Service Bulletin

Alternate Air Cable Inspection

GA8 serial numbers GA8-07-115 through GA8-08-130.

Document: Service Bulletin SB-GA8-2008-44,
Issue 2

Figure 1 Correct Cable Installation

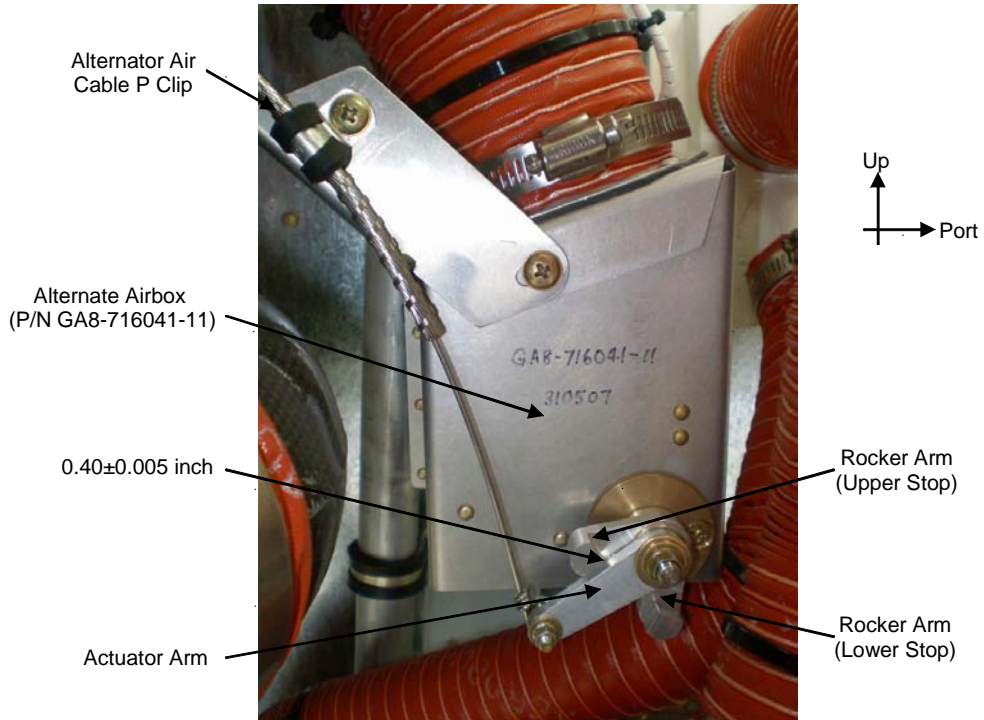
There is a possibility that the automatic alternate air door in the revised alternate air box (P/N GA8-716041-11) may be inhibited by the manual override cable, reducing the effectivity of the automatic alternate air door.

- 1.1. Remove the port side engine cowl access panel to gain access to the alternate air box.
- 1.2. With the alternate air knob fully in, there should be a gap of 0.40 ± 0.005 inch between the actuator arm and the upper stop of the rocker arm (see Figure 1). If the actuator arm is closer to the lower stop of the rocker arm (see Figure 2) with the alternate air knob fully in, complete the **2. Modification Procedure** detailed in this Service Bulletin. If the cable is installed correctly, on the Document Compliance Notice, record completion of the inspection procedure with no defect noted.

- 2.1. Loosen the P clip securing the alternate air cable to the air box such that the cable outer sleeve can move freely through it.
- 2.2. With the alternate air knob held in, feed the cable through the P clip until there is a gap of 0.040 ± 0.005 inch between the actuator arm and the upper stop of the rocker arm, and then tighten the P clip securing the alternate air cable to the air box.
- 2.3. Check for correct operation several times (refer to the **1. Inspection Procedure** in this Service Bulletin).
- 2.4. Reinstall the port side engine cowl access panel.
- 2.5. Record completion of the modification procedure on the Document Compliance Notice.
